TWO STROKE

Service Bulletin Index

SUZUKI SERVICE BULLETIN

Bulletin No. GT-1

SUBJECT: GT750 OIL STARVATION

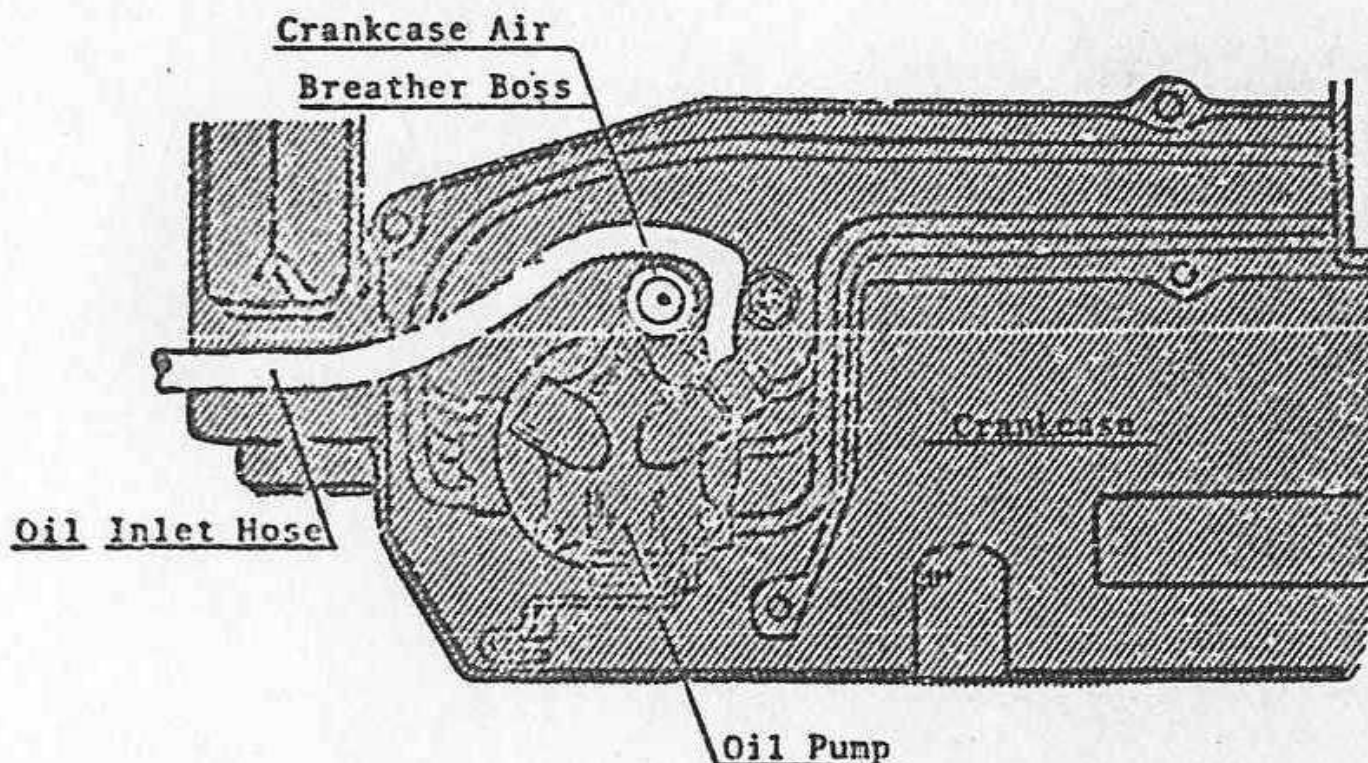
If care is not taken it is possible to pinch the inlet line from the oil tank to the oil pump when installing the oil pump cover. Pinching this line closed will result in no oil getting to the oil pump, or to the engine. Naturally this can cause a multitude of problems due to lack of lubrication.

1. Take special care that the oil pump inlet hose is routed around the crankcase air breather boss before installing the oil pump cover.
2. Before tightening down the screws holding the cover, check that the cover seats flush against the crankcase, without any gaps. If there is a gap, this would indicate that the hose might be pinched between the breather boss and the cover.
3. After tightening the screws, start the engine and check at the lines for any evidence of oil starving.

Note:

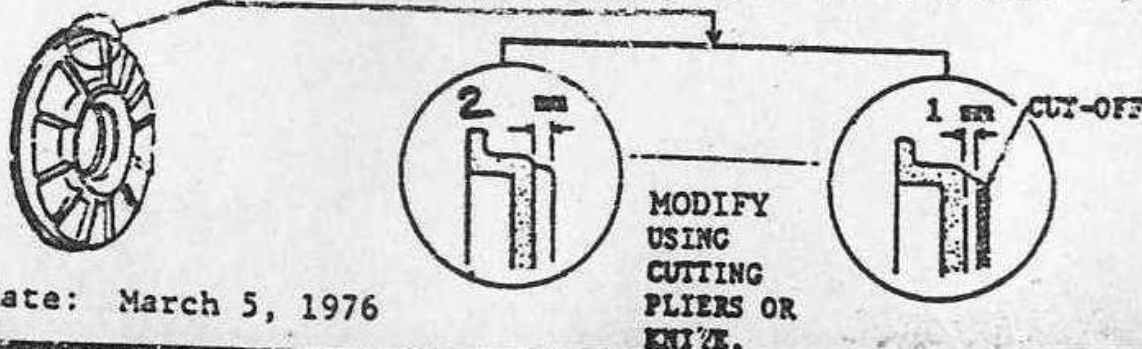
On future parts orders only the new type starter clutch parts will be supplied. However, the old type LH crankshaft oil seal will still be supplied until such time as the existing stock is exhausted. Therefore, when the old oil seal is retained in the unit and the starter clutch is modified or replaced, it is necessary to check the rib height of the oil seal and modify the same as shown.

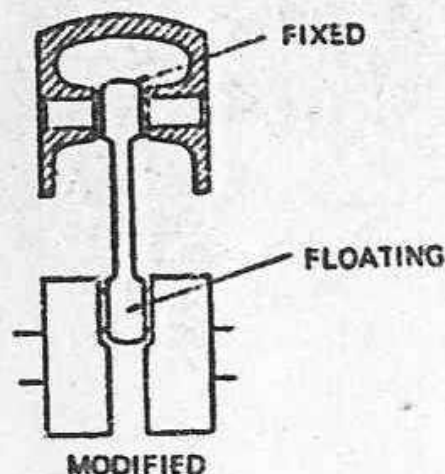
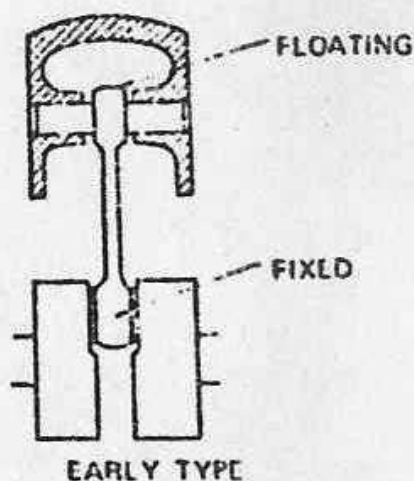
Side movement of the connecting rod is restricted on the small end, and the big end has been changed to a floating type as shown in the illustration below.

A) Crank Wheels:

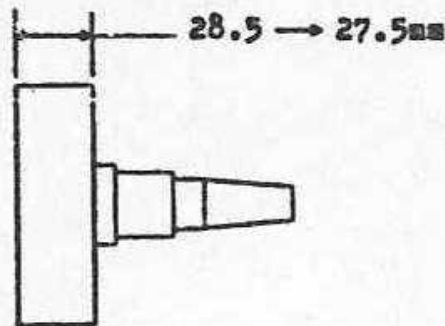
The width of the crank wheels has been reduced from 28.5mm to 27.5mm.

B) Pistons:

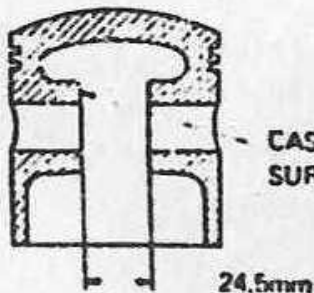
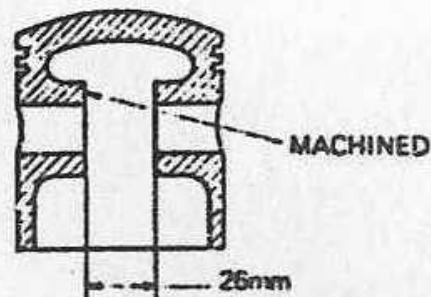
The pistons inside surface has been changed from a casting surface to that of a machined surface. The inside dimension between the wrist pin bosses has also been changed.

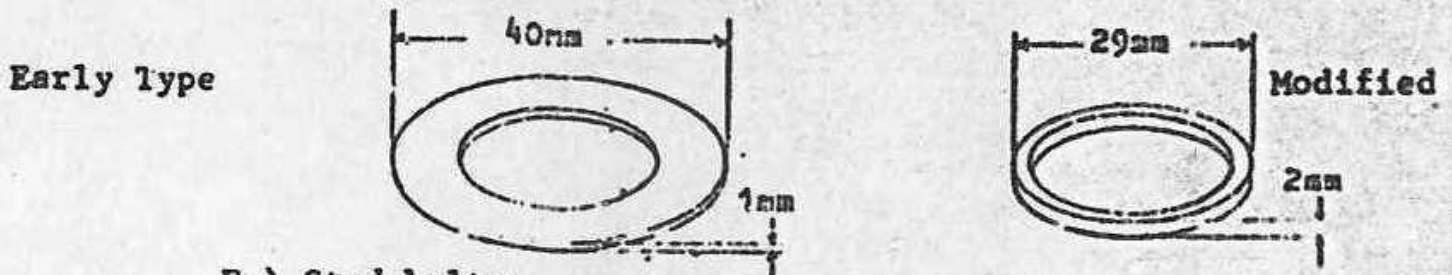
- C.) Thrust washer, connecting rod small end:
This thrust washer has been provided for the non-floating small end of the connecting rod. Two of these are used for each piston.

- D.) Thrust washer, crank pin bearing:
In order to have the connecting rod floating on the crank pin, this thrust washer has been modified as shown below.

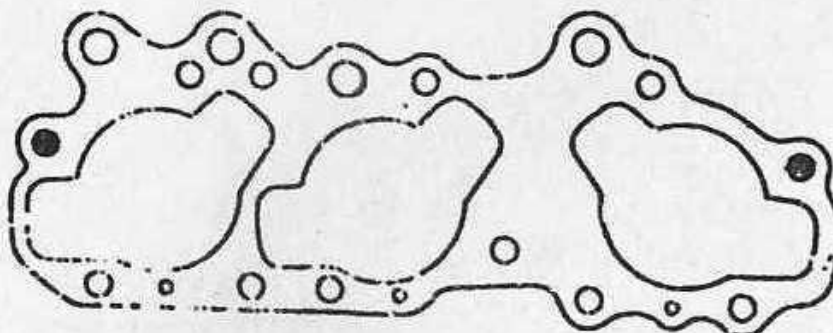
- E.) Stud bolts:
Two of the twelve stud bolts on the crankcase assembly have been replaced with a new type shouldered bolt.

- F.) Cylinder gasket:
Two holes in the gasket have been enlarged from 11mm to 12.5mm in diameter to match the new type stud bolts.

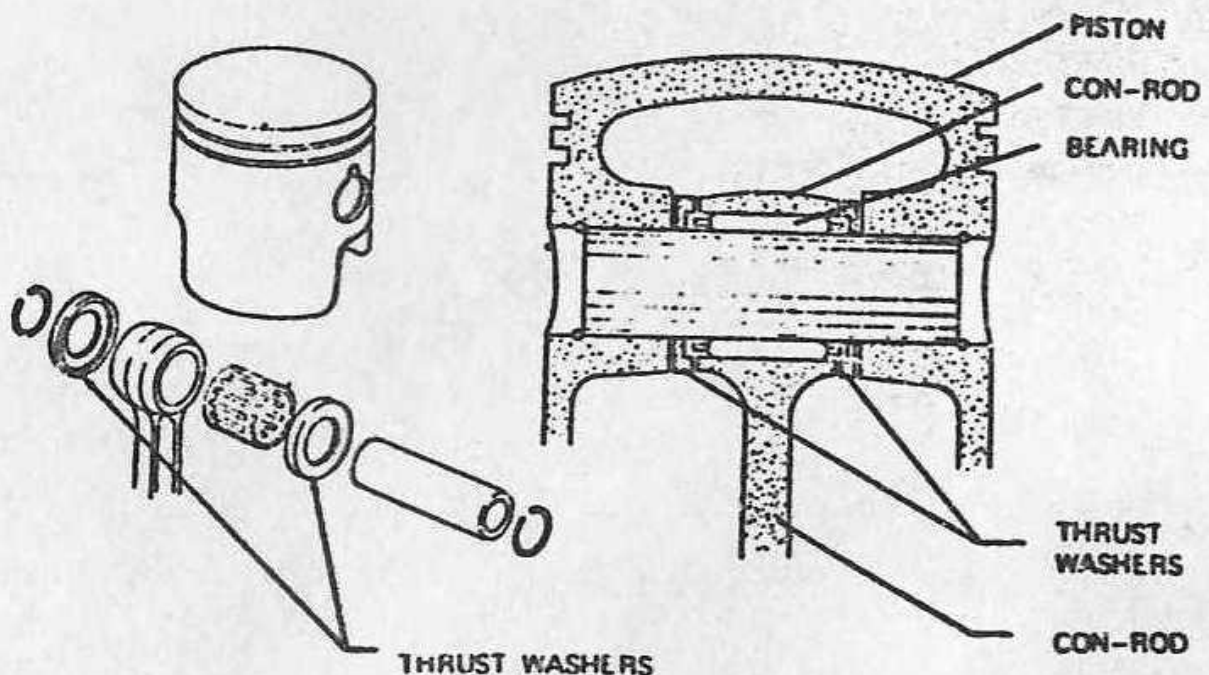
- 1) The pistons and thrust washers should be assembled as shown below.

NOTE: Two different pistons are used in the GT750 engine, and they are marked "R" and "L" on top of the piston crown. The "R" piston is for the right cylinder and the "L" pistons are for the left and middle cylinders.

SUBJECT: T500 TRANSMISSION REPAIR

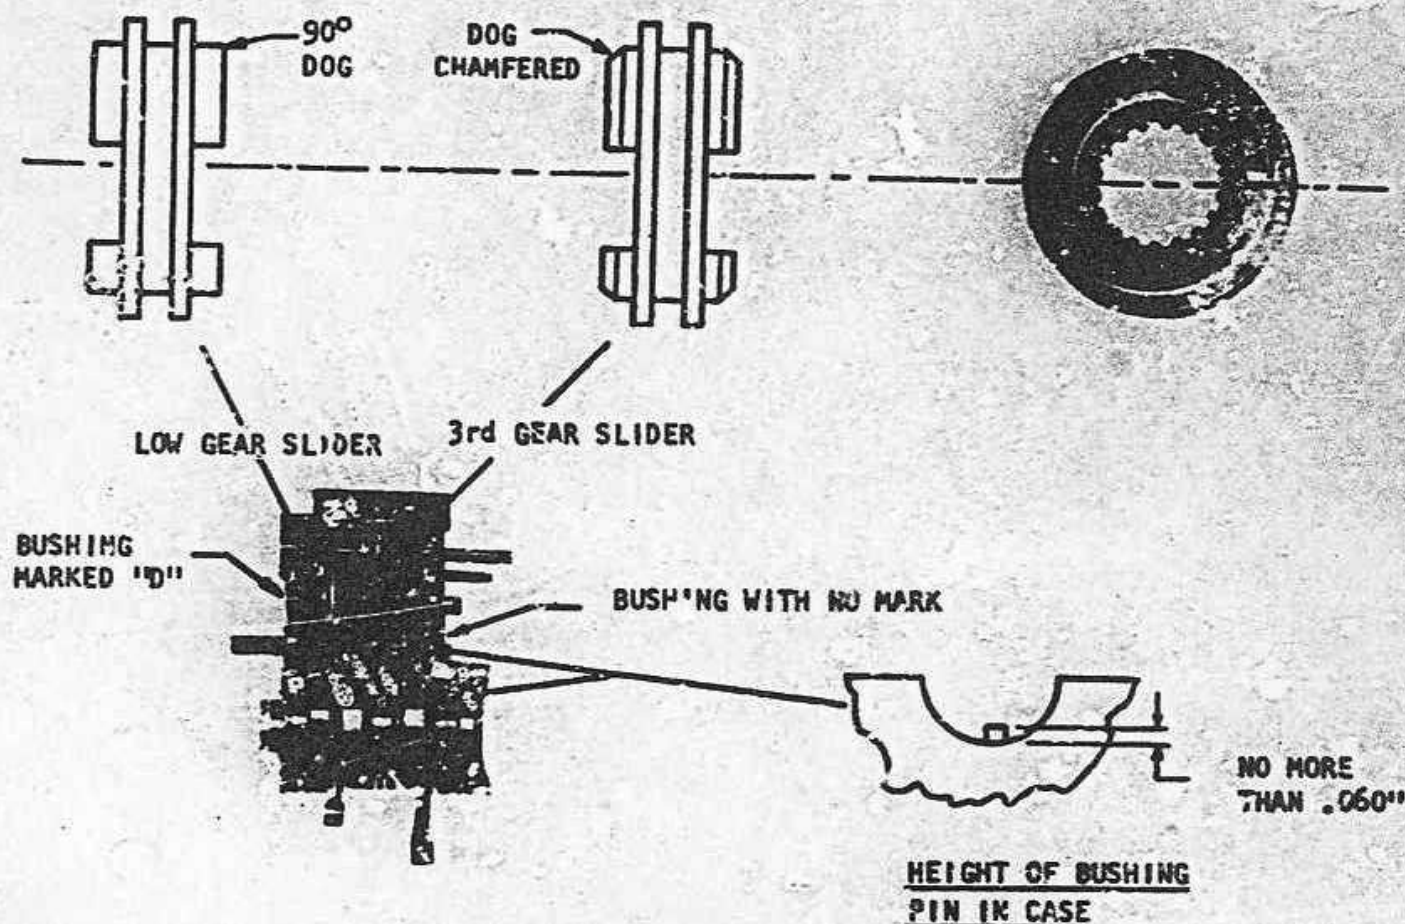
- A. Do not interchange low gear slider wheel with 3rd gear slider wheel. If the transmission is assembled this way, the bike will jump out of first gear under any load. The difference between the two wheels is shown below:

T500 Transmission Repair

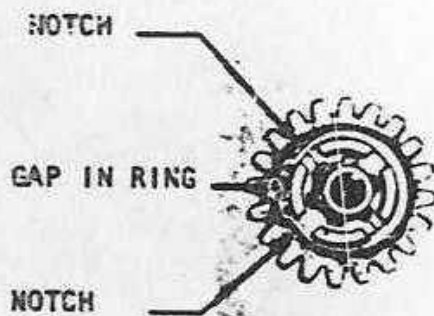
- C. Be absolutely sure that all bushings and bearings are properly located over the pins in the lower crankcase. We have had ruined crankcases from failure to follow this simple step. This is not a factory defect and we expect the servicing dealer to bear the expense of repair for this type of damage.
- D. Use new snap rings when assembling gear locating rings to transmission shaft.
- E. Locate the gap in the snap ring away from the notches in the gear. This keeps the snap ring from popping loose if the tabs move over. Be sure that the ends of the snap rings do not butt. If they do, cut off until there is at least a 1/16" gap.

RIGHT
RING GAP CENTERED
BETWEEN GEAR NOTCHES

GAP IN RING
NOTCH
IN GEAR

WRONG
GEAR LOCATING RING
TABS CAN POP OUT

SUBJECT: T250, T305, T350 DRIVE SHAFT/TOP GEAR

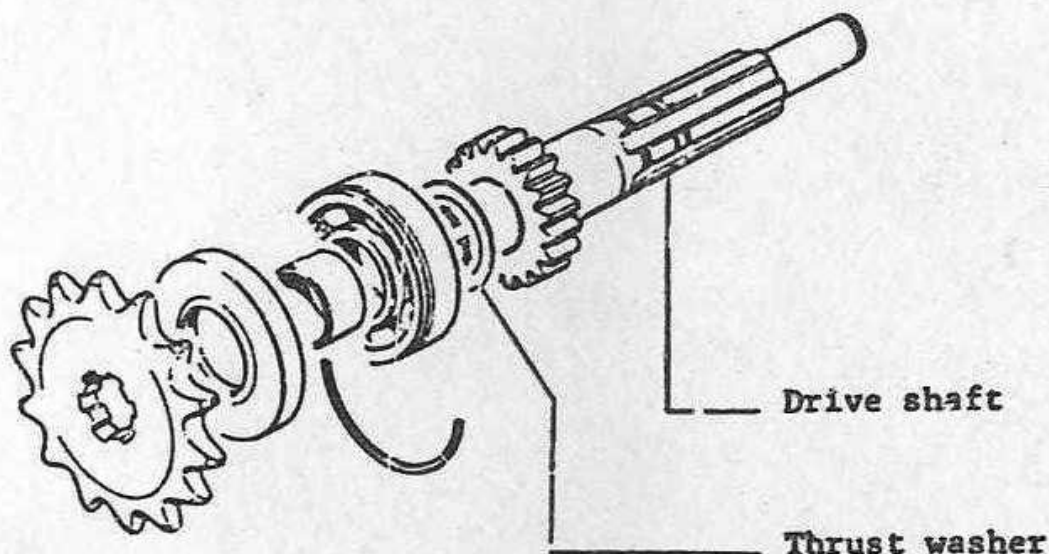
Top gear, driven, on the subject models has been increased in thickness and strength.

When using the new style driveshaft #24131-18002 with old style crankcases, the thrust washer #08211-22341 must be eliminated.

In the event that new cases are fitted and the old driveshaft re-used, washer #08211-22341 must be retained.

SUBJECT: T500 INCREASED TRANSMISSION OIL CAPACITY

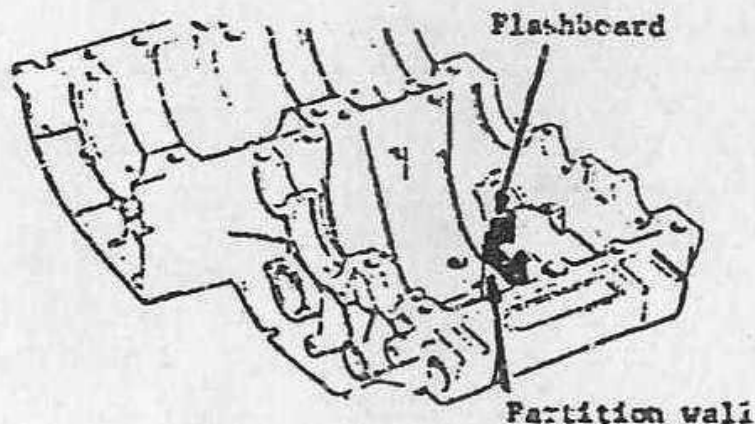
A rubber flashboard applied to the primary oil transfer chamber in the lower crankcase half is used to accommodate the increased oil capacity. The flashboard keeps the additional oil from entering the primary case, and therefore protects the clutch from excessive drag.

The flashboard in position is illustrated below.

The rubber flashboard is now available from the U. S. Suzuki Parts Department for T500's prior to the 1974 "L" model. Its application is strongly recommended whenever the crankcases are disassembled.

SUBJECT: T500 SWING ARM PIVOT SHAFT
REFERENCE: Service Bulletin #TC/TS-17

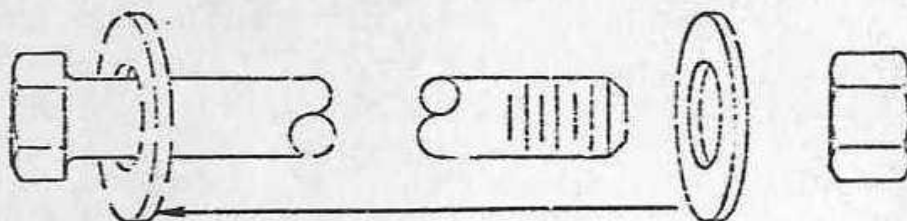
The shoulder radius of the T500 swing arm pivot shaft has been increased from 0.5mm to 1.0mm.

To accept the new type pivot shaft, the frame boss chamfer has also been increased 0.5mm.

NOTE: Should it be necessary to install a new type pivot shaft through an old type frame boss, simply move the washer from the nut side to the head side of the swing arm pivot shaft. The washer will conform to the shoulder radius of the pivot shaft.

SUBJECT: T500 SHIFTING CAM GUIDE BOLT LOCATION

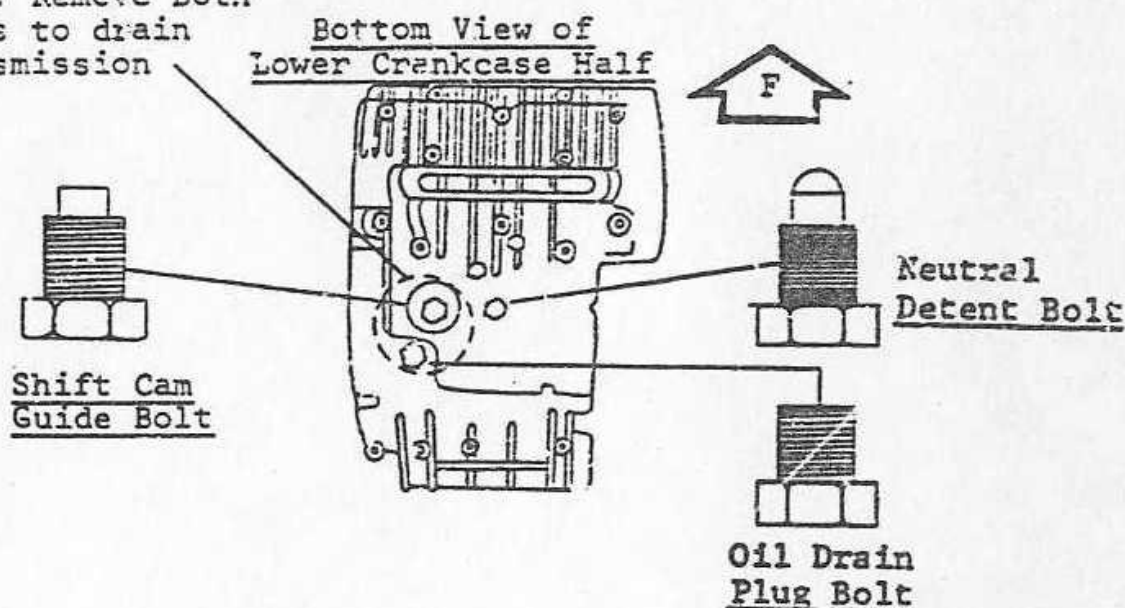
We have received occasional reports of T500 transmission failure immediately after an engine or transmission overhaul. Upon disassembling and inspecting the transmission, two situations have been found. The first reason a transmission would fail was that an oil drain plug bolt from another model Suzuki (Example TS185/250) had been interchanged with the shift cam guide bolt during the overhaul. The second reason for the transmission failure was due to a magnetic oil drain plug that had been substituted instead of the shift cam guide bolt.

In both situations the bolt did not extend into the locating groove of the shift cam drum far enough to restrict the shift drum from sliding from side to side in the crankcases. When this happens the shifting forks slide with the shift cam, allowing two sets of gears to become engaged at the time. This results in severe damage to the gears, and requires their replacement.

Therefore, whenever a T500 is overhauled, or the transmission oil changed by your service department, the final inspection after reassembly should be the proper placement of the shift cam guide bolt.
